Three Mile Island Nuclear Station, Unit 1  
Renewed Facility Operating License No. DPR-50  
NRC Docket No. 50-289

Subject: Response to Request for Additional Information  
TMI Fall 2017 Steam Generator Tube Inspection Report

**Response to Request for Additional Information  
TMI Fall 2017 Steam Generator Tube Inspection Report**

**Figure 1: TMI-1 Condition Monitoring of TSP Wear at T1R22 (SG B) and T1R21 (SG A) Based on Bobbin Sizing**

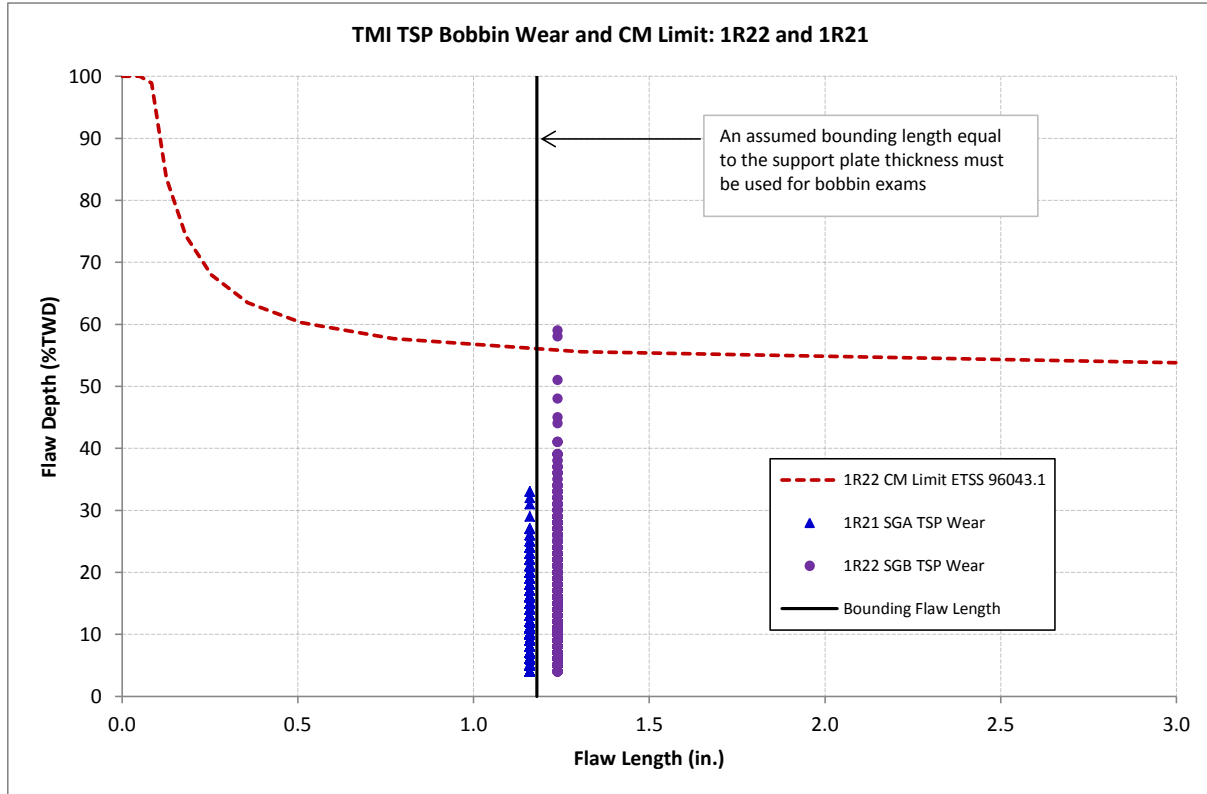
The NRC staff notes that each of these high growth rate flaws have been identified in SG B and that the root cause for these flaws has been attributed to tube support plate partial locking to the shroud at the wedges and alignment keys. Although SG A has not experienced the same phenomenon with high growth rate flaws, it is unclear to the staff if the same mechanism could become active in SG A at some point during future operation. Please discuss the results of condition monitoring and operational assessment that provide assurance that tube integrity will be maintained for SG A until the next scheduled inspection.

Condition Monitoring assessments have been performed on both SGs since the first inservice inspection (T1R19 in 2011). SG A, unlike SG B, has passed Condition Monitoring acceptance criteria analytically by a wide margin at all three of its inspections, including T1R21. Given that SG A has not exhibited and is not expected to exhibit the high wear behavior as SG B, there is confidence that SG A will again meet Condition Monitoring after operating for two cycles.

While there are, expectedly, certain similarities in the behavior of broached tube support plate wear in both SGs, SG B has consistently exhibited distinct patterns of aggressive wear in certain locations that differ significantly from SG A. SG A lacks distinct patterns of aggressive wear. As a point of comparison, Figure 1 plots the TSP wear depths for SG A and SG B at T1R21 and T1R22, respectively, compared to the T1R22 CM limit curve. This shows the large difference in the depth distribution and margin to the CM limit between the two SGs. In addition, the wear depths and growth rates in SG A are in line with other replacement EOTSGs in the US nuclear fleet. As described above, there is sufficient qualitative and quantitative evidence to support the hypothesis that SG A is not subject to the tube support plate partial locking phenomenon that affects SG B and has been a contributing factor to the aggressive broached tube support plate wear observed. It is therefore justifiable to treat SG A differently than SG B in their Operational Assessments (OAs).
